Product Support Bulletin 2010-003

Maintenance of Way ~ Work Equipment Bulletin

SUBJECT: Rail Lift Manifold Block Kit – 98760072

MACHINE MODEL(S): TRIPP Tie Exchanger

Figure 1
Location of Rail Lift Manifold and Mounting Blocks

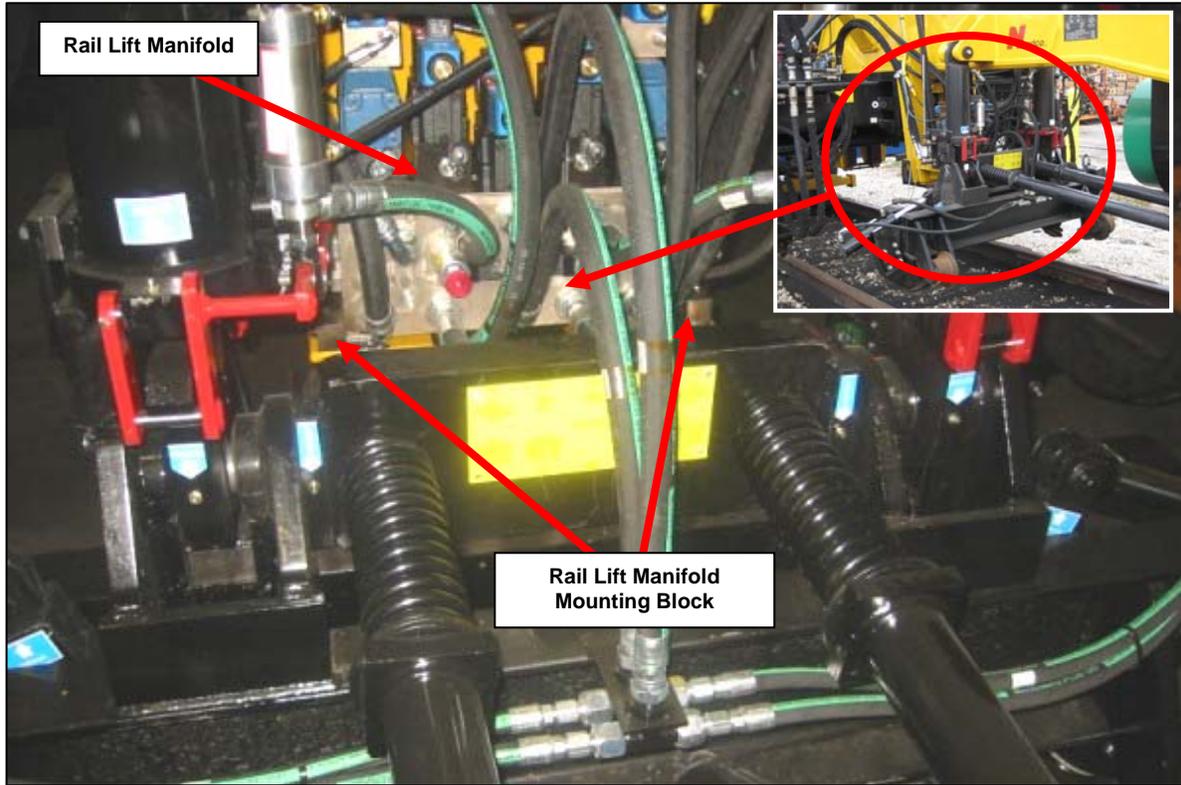
SUMMARY: The Rail Lift Manifold is mounted on the machine using mounting blocks secured to the manifold with four 3/8" Grade 5 capscrews. There have been several reports of failures of these mounting capscrews. See Figure 1 on Page 2.

The capscrews usually break because they loosen during operation. Usually only one or two of the capscrews will break, and the manifold will still be secured to the machine, but removing the broken bolts could be difficult if they break off flush with the manifold.

Figure 2
Stepped Manifold Mounting Block Included in Kit 98760072

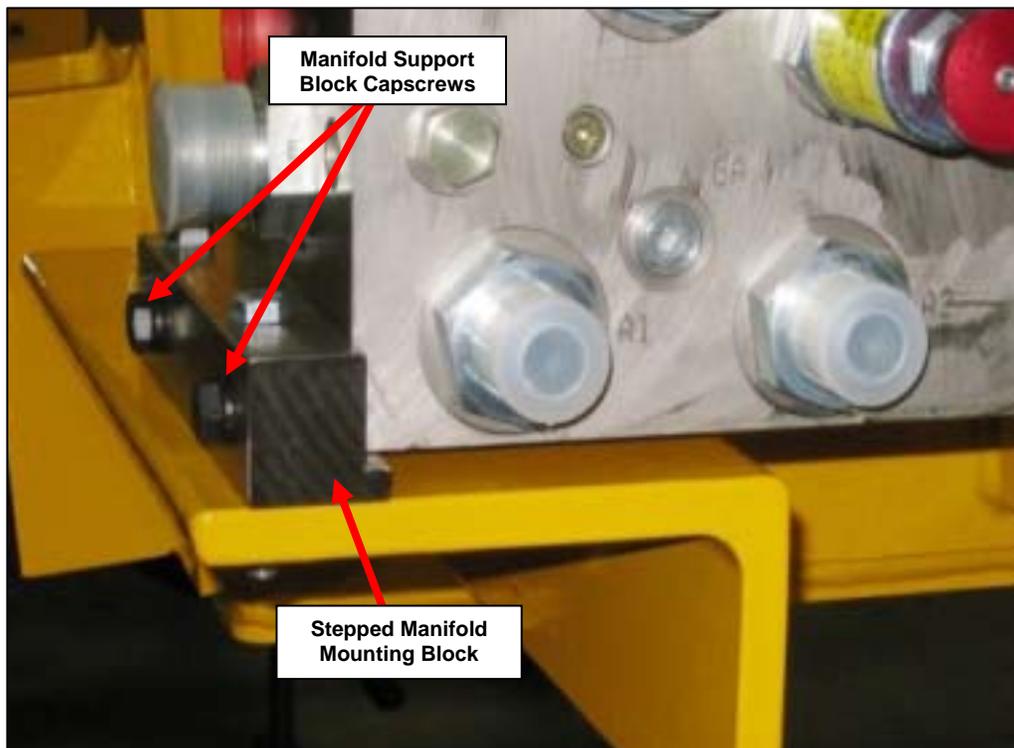
The mounting capscrews should be checked periodically for tightness. To help support the manifold, stepped mounting blocks may be installed to replace the original mounting blocks. **Rail Lift Manifold Block Kit, p/n 98760072**, is available from Nordco to install the stepped mounting blocks. This kit includes two Mounting Blocks and mounting hardware. One kit is required per machine. **Be sure to follow all Lock Out/Tag Out procedures before installing this kit.** Contact the Nordco Parts Department at 1-800-647-1724 to order this kit. Machines starting with 760367 will have the stepped mounting blocks installed at the factory. See Figure 2 on Page 2.
